RE: Ore Peninsula Redevelopment Project, Pacific Pile & Marine
Change Order No. 005

Date: March 5th 2024

Scope of Changes (Change Order 005):

Subject: Ore Peninsula Redevelopment Project
RFP – Upland Slab – PCO 003

DRAWN: MSM PROJECT NO.: 10849.22001
 DESIGN: MSM SCALE: AS SHOWN
 CHECKED: JMP DATE: 08/09/2023
 DRAWING NO. **C3.16**
 SHEET NO. OF

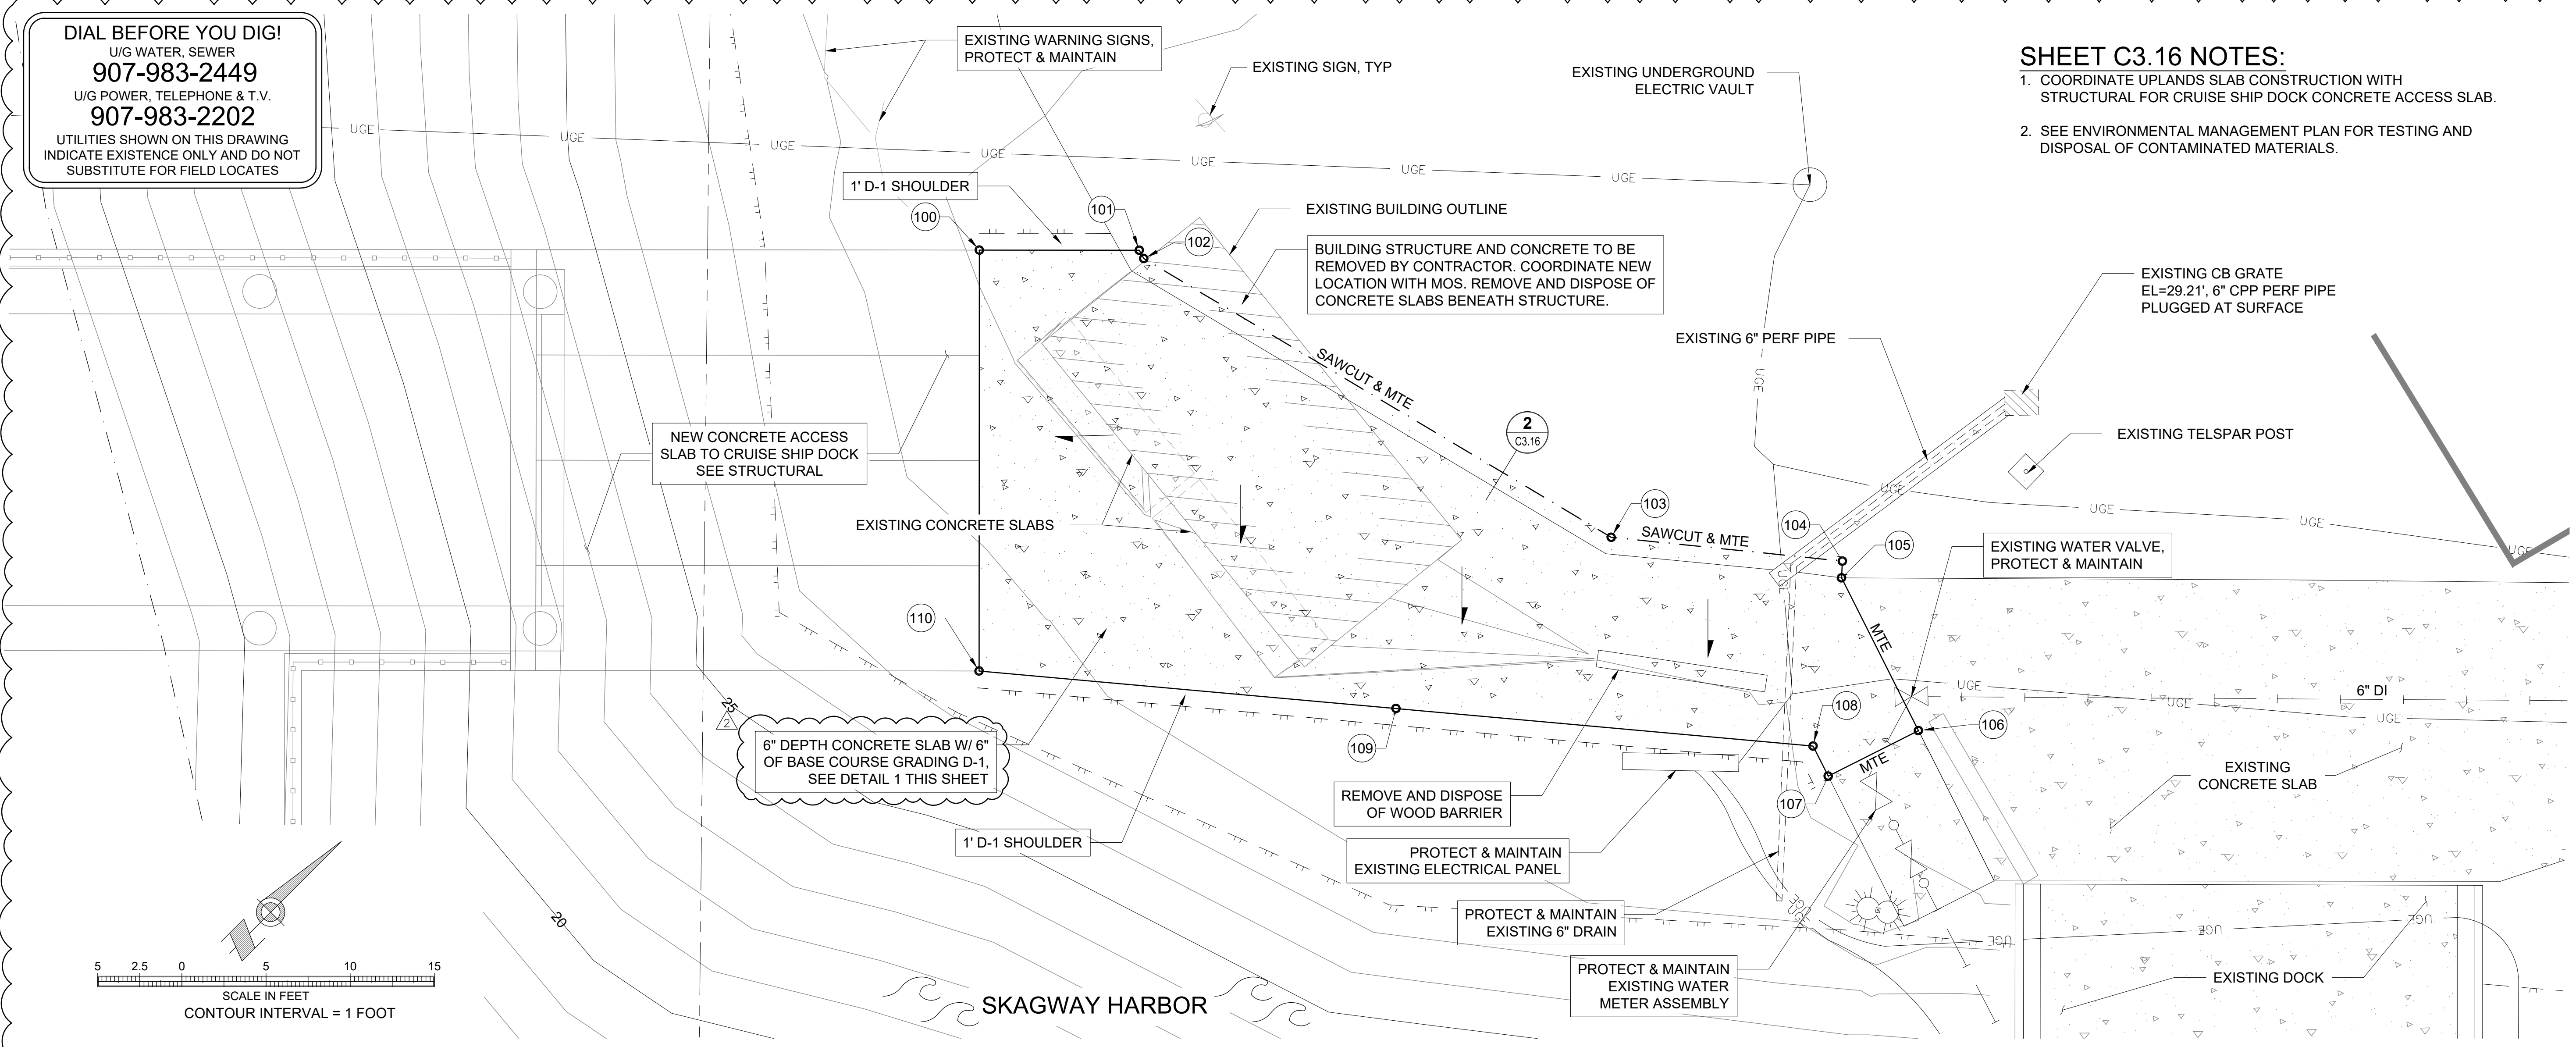
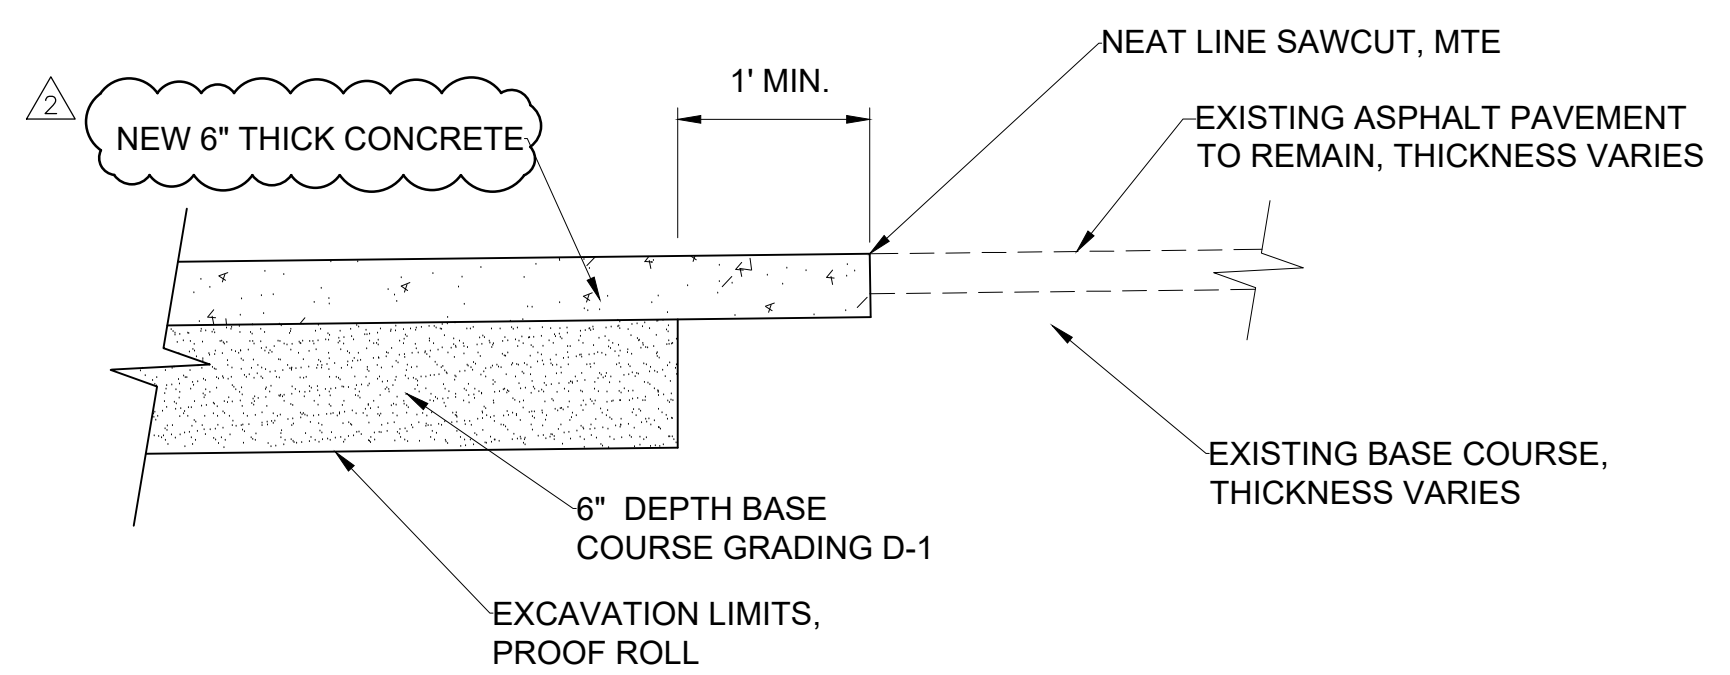
The proposed upland civil work in the attached drawing outlines the addition of 105 square yards of temporary concrete paving to accommodate pedestrian and vehicular access to the float during the cruise season. The work is directly adjacent to the cruise ship dock concrete access slab and will result in approximately 29 cubic yards of native soil excavation and disposal. All existing utilities shall be protected-in-place and not altered or improved as part of this upland civil paving plan.

NO.	DATE	BY	REVISION
1	8/9/23	MSM	REVISION 2 - TEMPORARY PAVING PLAN
2	2/20/24	MSM	REVISED GRADES & SLAB DEPTH

DRAWN: JH	PROJECT NO.: 2100135
DESIGN: ED	SCALE: AS SHOWN
CHECKED: RR	DATE: 07/21/2023
DRAWING NO.	S3.24
SHEET NO.	184 OF 381

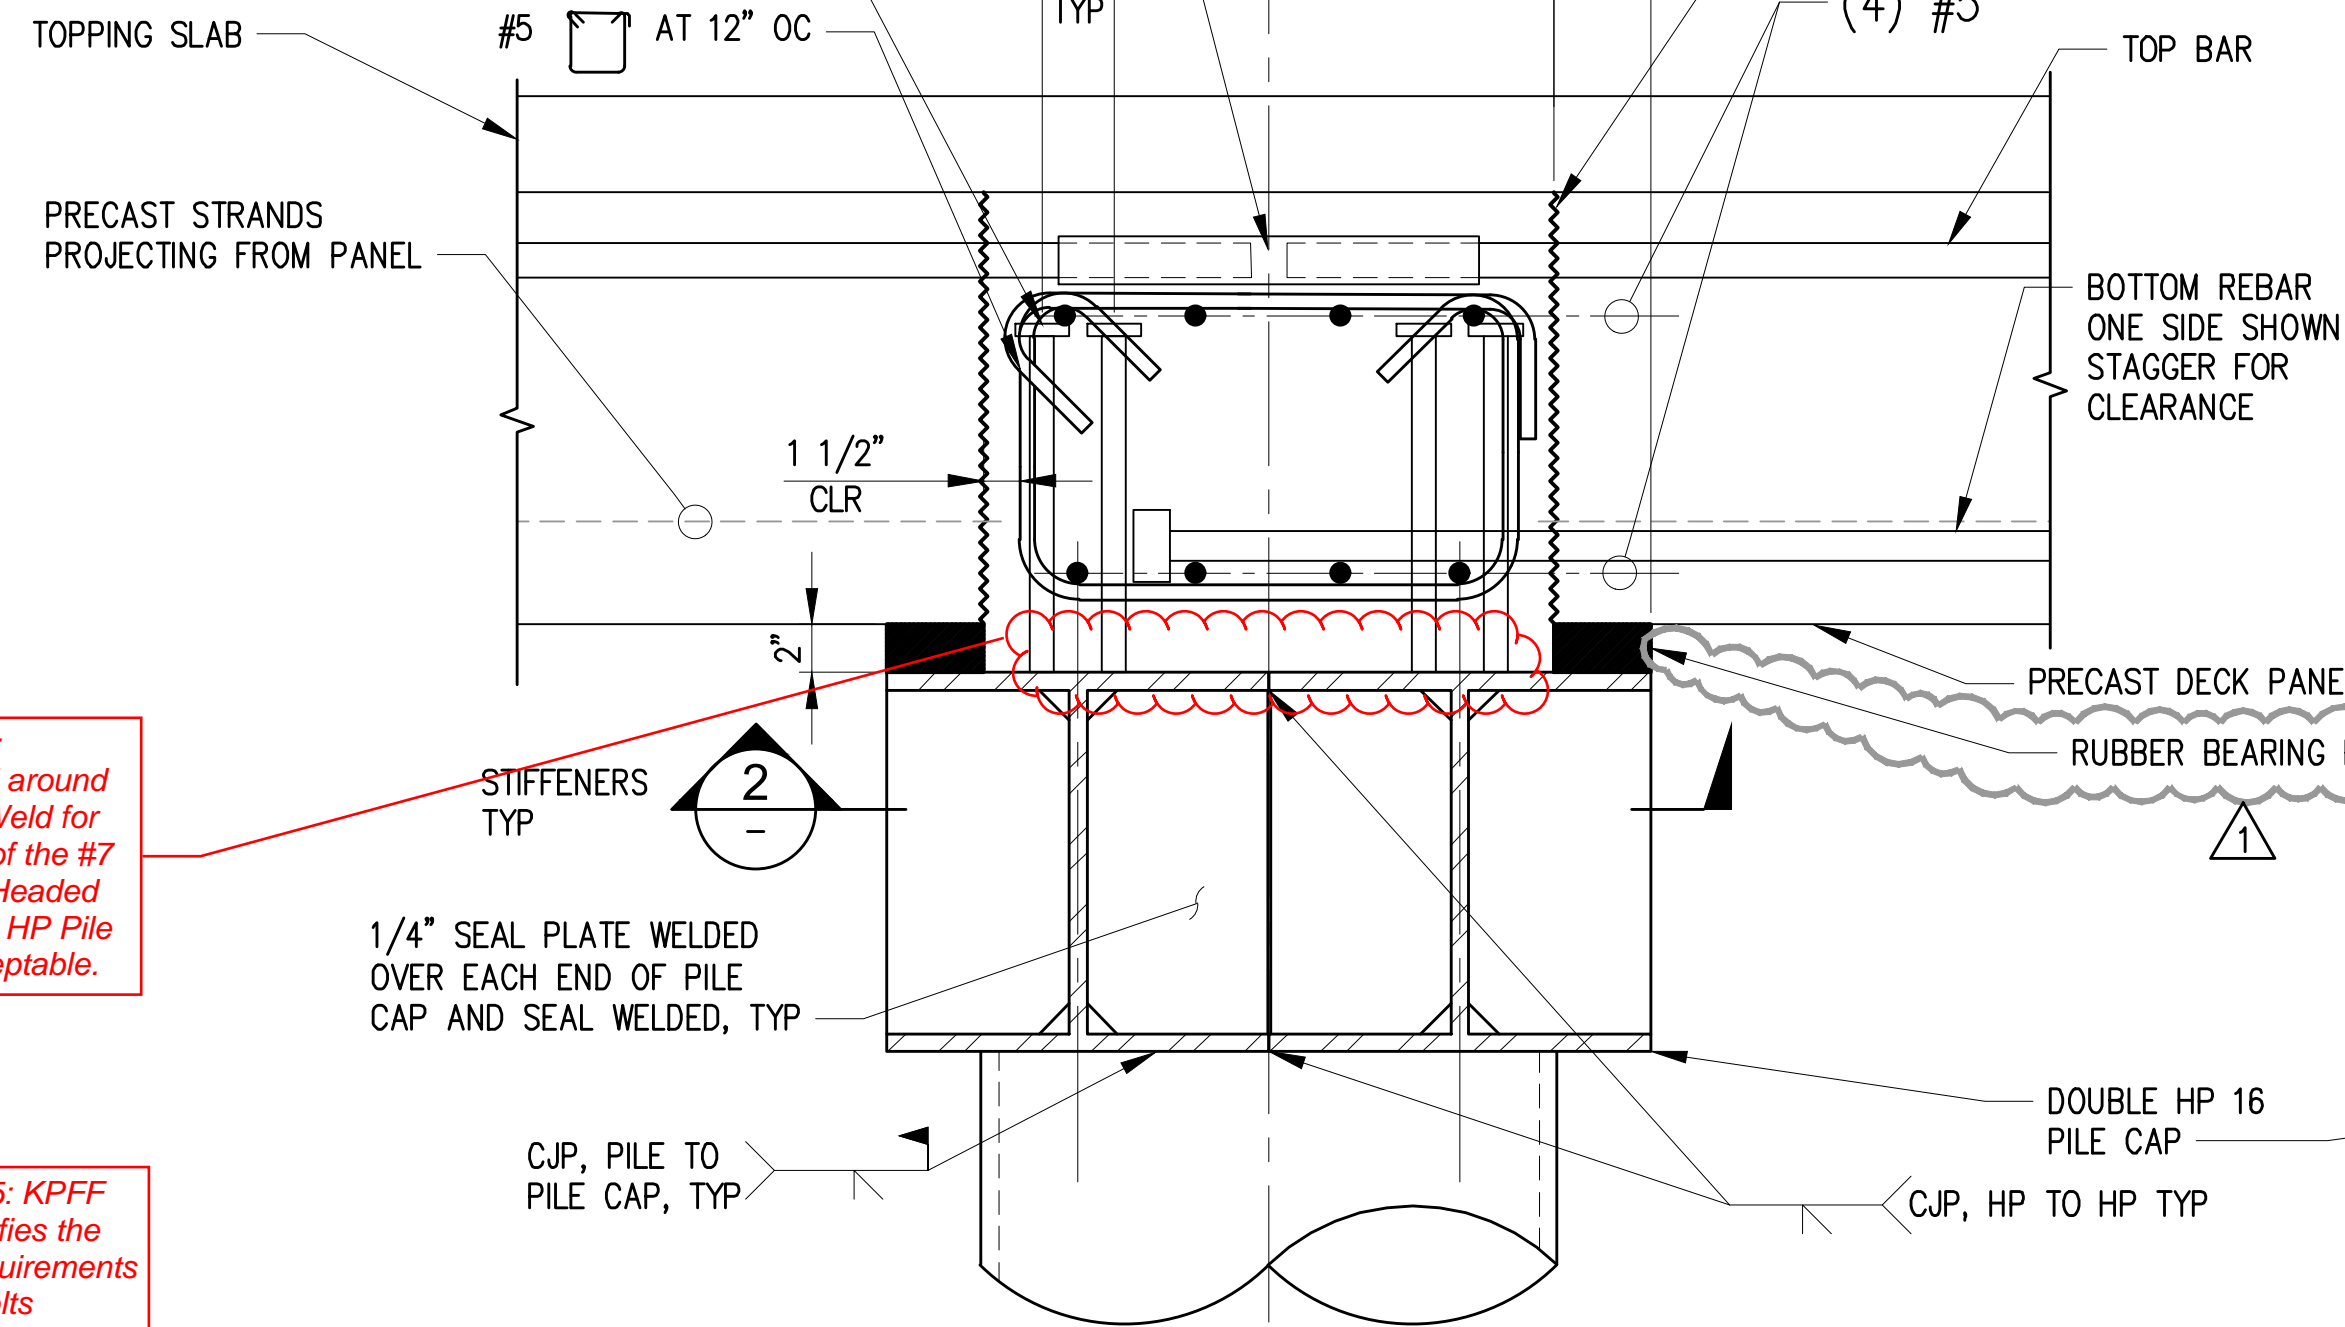
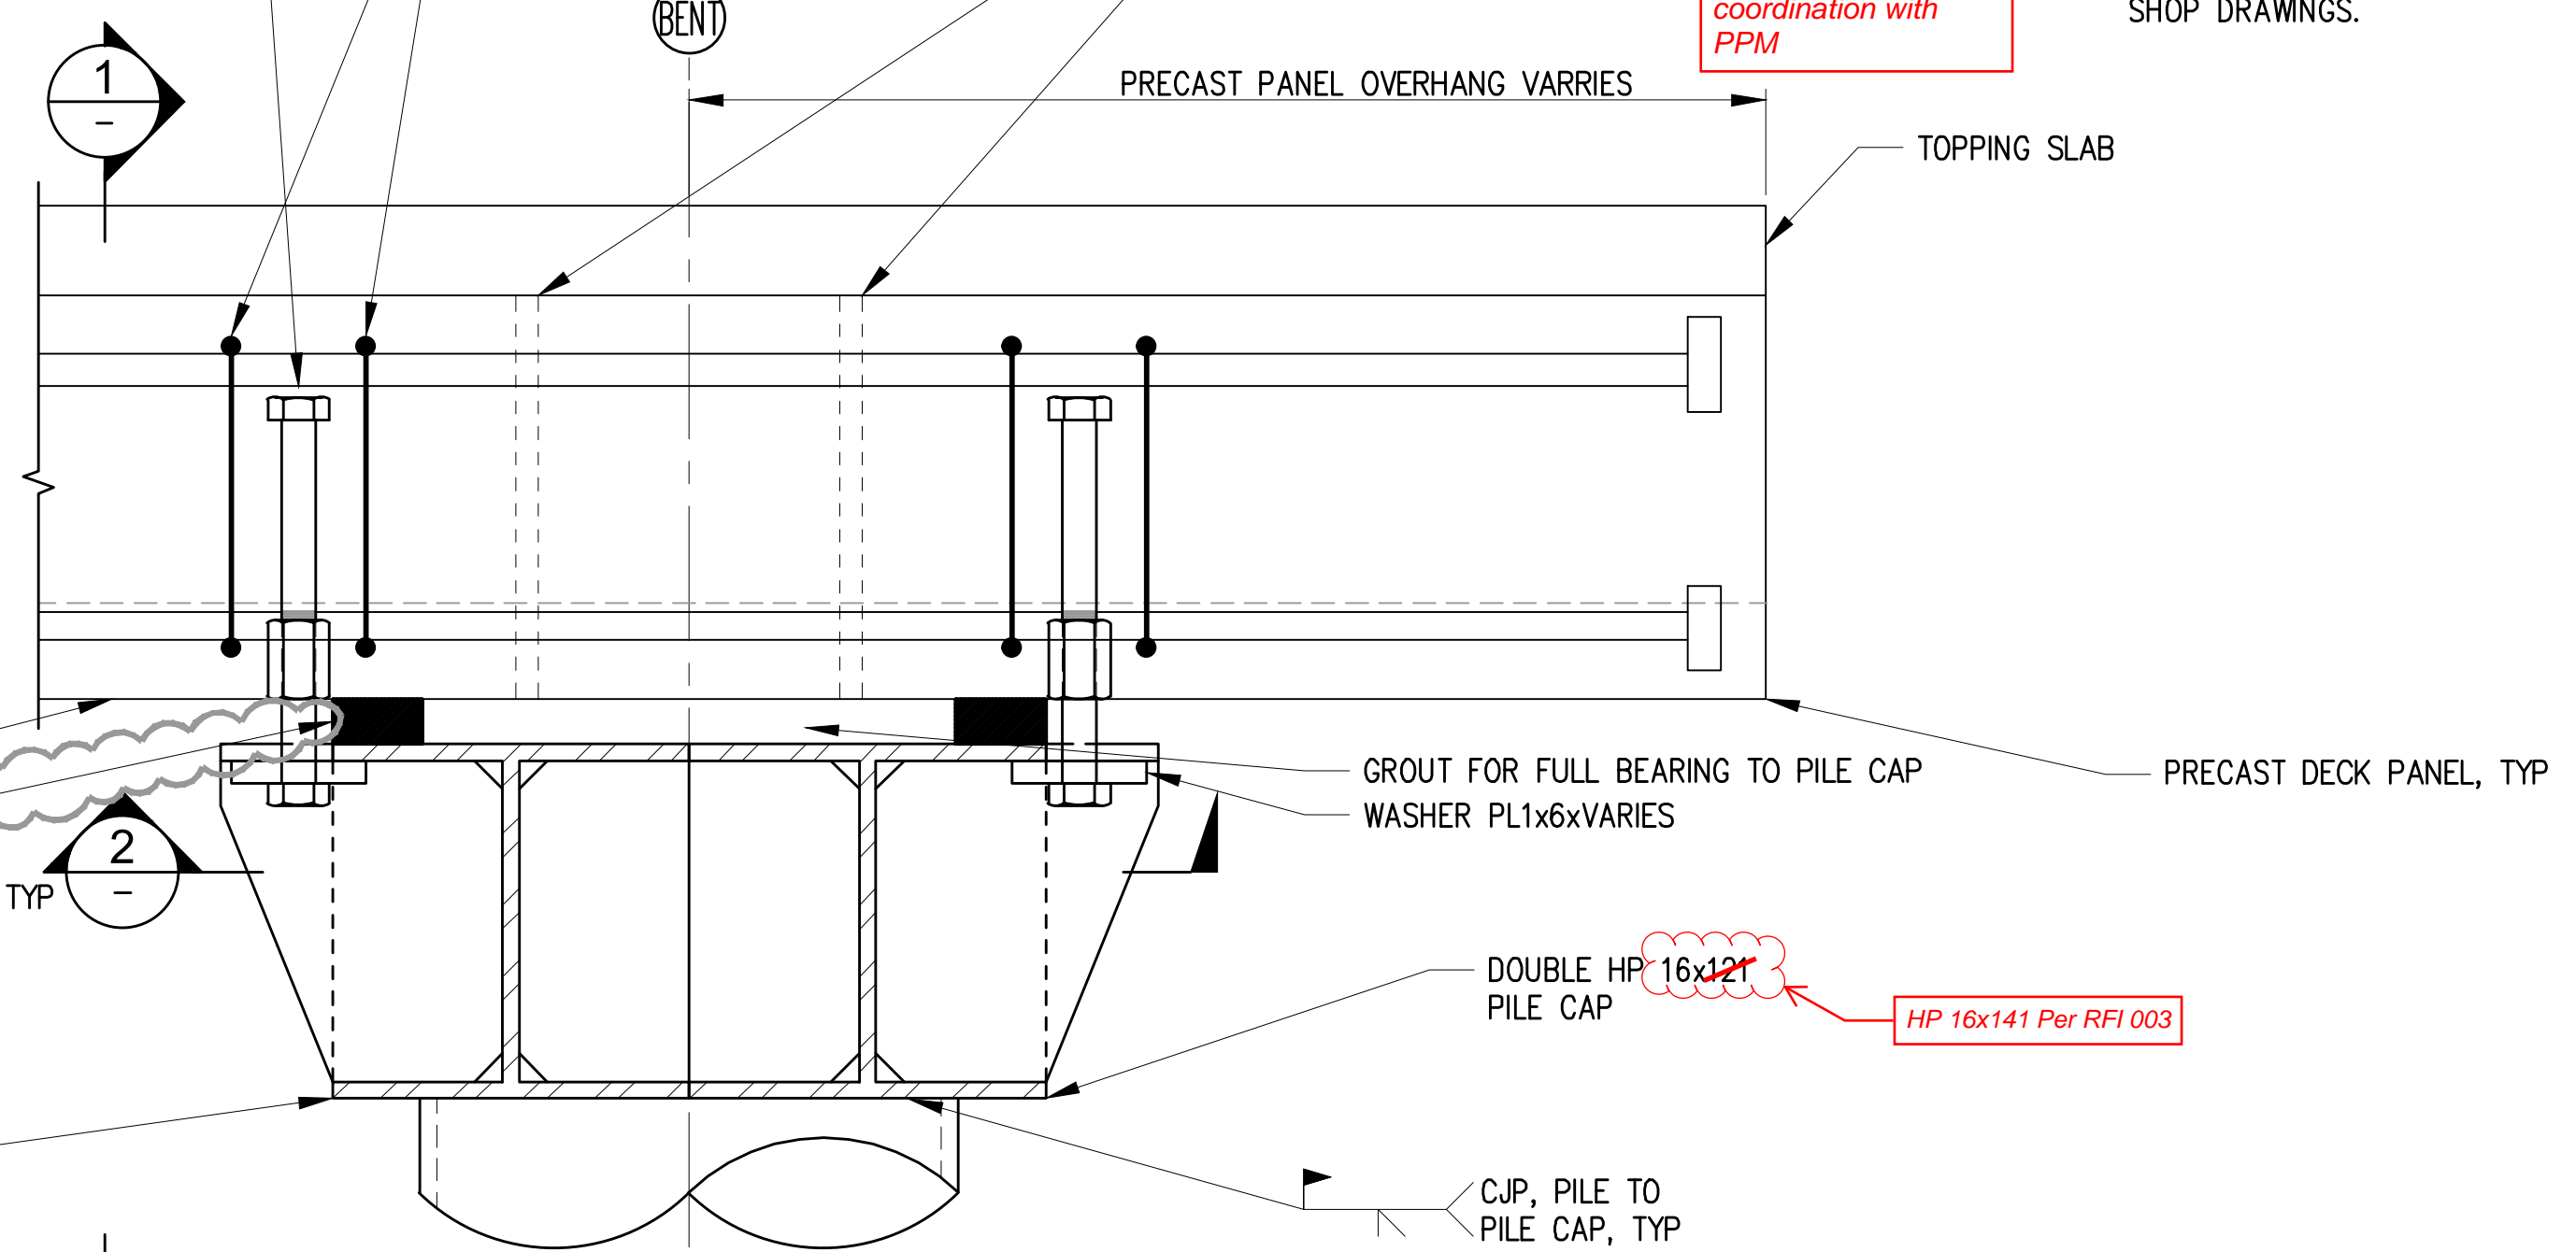
Hold-Down Bolts and Stiffeners - Additional (72) hold-down bolts and stiffeners to cover both sides of the pile caps as well as the 4 bolt connection at each pile location per IFC drawing S3.24
Headed Bar Spacing - Additional (140) headed studs to accommodate 7" OC spacing as shown on Detail A S3.24 and clarified in RFI 005.
Additional detailing costs - Additional detailing required for multiple shop drawing iterations to account for PCO 021 design changes.

Per RFI 005: grout tube - sizing and projection - CTC coordination with PPM

Per RFI 004: Use of an all around 5/16" Fillet Weld for attachment of the #7 or #8 sized Headed Rebar to the HP Pile Caps is acceptable.

Per RFI 005: KPFF Sketch clarifies the spacing requirements for these bolts

Clarifying details provided in RFI 005 Sketch provided by KPFF
